# Access Compliance Report

## Public Rights-of-Way (Curb Ramps)

Intersection ID: 23899	Main Street: CARTGATE_LN	Cross Street: STEPHENDALE_DR	Location: SW
ADA ID: 9F3935FF57B1	Ramp Type: PerpDiag	Initial Pass/Fail: Fail	Overall Compliance: No
		Severity Score: 21.25

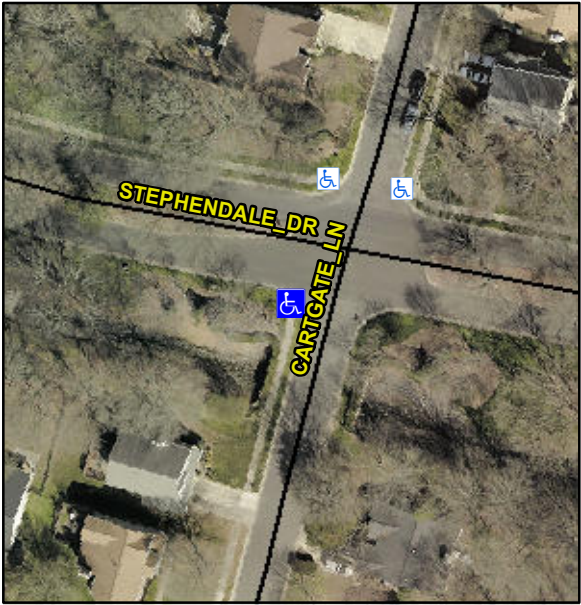
Codes/Mitigation Info/Possible Solution			Field Measurements/Component Compliance		
	Possible Solutions:		<b>Compliance</b>	<b>Description</b>	<b>Data</b>
	<b>Remove &amp; Replace Curb Ramp With Two New Directional Ramps or Equivalent.</b>		<b>No</b>	Ramp Length (in)	<b>89.0</b>
			<b>No</b>	Ramp Width (in)	<b>45.0</b>
			<b>N/A</b>	Flare Type LT	<b>N/A</b>
			<b>N/A</b>	Flare Slope LT (%)	<b>N/A</b>
			<b>N/A</b>	Flare Traversable LT?	<b>N/A</b>
			<b>N/A</b>	Landing Length (in)	<b>N/A</b>
			<b>N/A</b>	Landing Width (in)	<b>N/A</b>
			<b>N/A</b>	Landing Slope (%)	<b>N/A</b>
			<b>N/A</b>	Landing X Slope (%)	<b>N/A</b>
			<b>N/A</b>	Landing Curb? (Y/N)	<b>N/A</b>
			<b>N/A</b>	Shared Landing?	<b>N/A</b>
			<b>N/A</b>	Gutter Ponding?	<b>N/A</b>
			<b>N/A</b>	Gutter Lip Ht (in)	<b>N/A</b>
			<b>No</b>	Painted X Walk1?	<b>No</b>
				X Walk 1 Direction	<b>To SE</b>
			<b>N/A</b>	X Walk 1 Width (in)	<b>N/A</b>

X Walk 1 Slope (%)	<b>1.0</b>
				X Walk 1 X Slope (%)	<b>1.4</b>
			<b>N/A</b>	Ramp inside XWalk1?	<b>N/A</b>
<p>Surveyor Notes:</p> <p><b>N/A</b></p> <p>PROW/ADA:</p> <p><b>Not Found, R304.5.1, R304.2.2</b></p>			<b>N/A</b>	Flare Type RT	<b>N/A</b>
			<b>N/A</b>	Flare Slope RT (%)	<b>N/A</b>
			<b>N/A</b>	Flare Traversable RT?	<b>N/A</b>
			<b>N/A</b>	DWS Provided?	<b>N/A</b>
			<b>N/A</b>	DWS Contrast?	<b>N/A</b>
			<b>N/A</b>	DWS Length (in)	<b>N/A</b>
			<b>N/A</b>	DWS Full Width?	<b>N/A</b>
			<b>N/A</b>	DWS Offset (in)	<b>N/A</b>
			<b>N/A</b>	Gutter Slope (%)	<b>N/A</b>
			<b>N/A</b>	Gutter X Slope (%)	<b>N/A</b>
			<b>N/A</b>	Painted X Walk2?	<b>No</b>
				X Walk 2 Direction	<b>To NE</b>
			<b>N/A</b>	X Walk 2 Width (in)	<b>N/A</b>
				X Walk 2 Slope (%)	<b>3.7</b>
				X Walk 2 X Slope (%)	<b>0.1</b>
			<b>N/A</b>	Ramp inside XWalk2?	<b>N/A</b>
			<b>N/A</b>	Clear Space?	<b>N/A</b>
			<b>N/A</b>	Clear Space to XWalk (in)	<b>N/A</b>
